Type <b>Coffee Vending Machine</b>	Model <b>95</b>	N° T.I. <b>06 - 2023</b>
Serial Number <b>24024490</b>	Subject <b>CAPACITIVE KEYBOARD WITHOUT GIGABIT PORT</b>	ISSUED FOR (X) Action Information <b>X</b>

**REASON:**

Due to shortage of the Gigabit Ethernet modules present on the current capacitive keyboards

CUP board detail

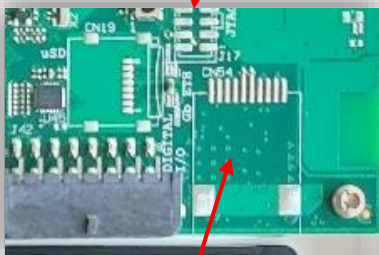
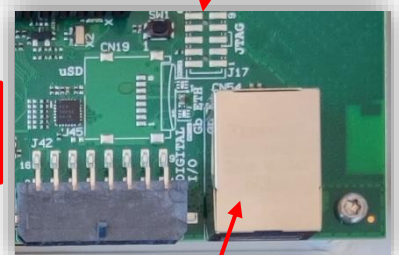
Since the Ethernet connection is now little used unlike Wifi and 4G solutions, the *Ethernet port* and its *chip* have been removed from the CPU board, contained in capacitive keyboards.

*Ethernet port*  
has been removed

*Ethernet port*

**Modified** CPU board (Bottom view)

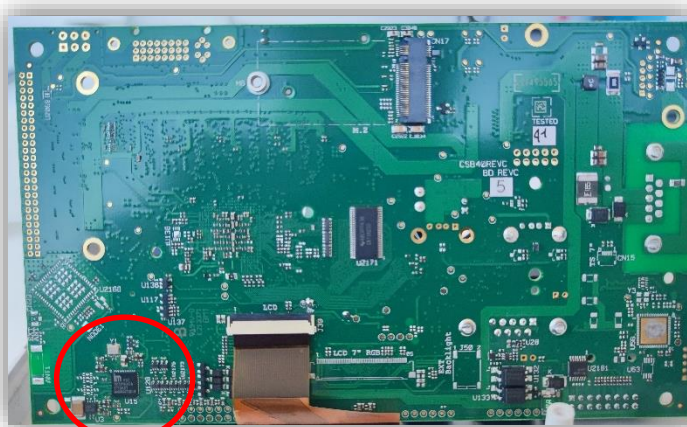
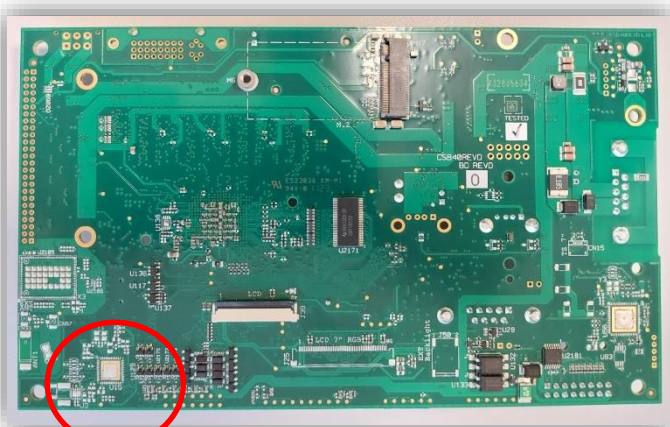
Chip removed

Chip
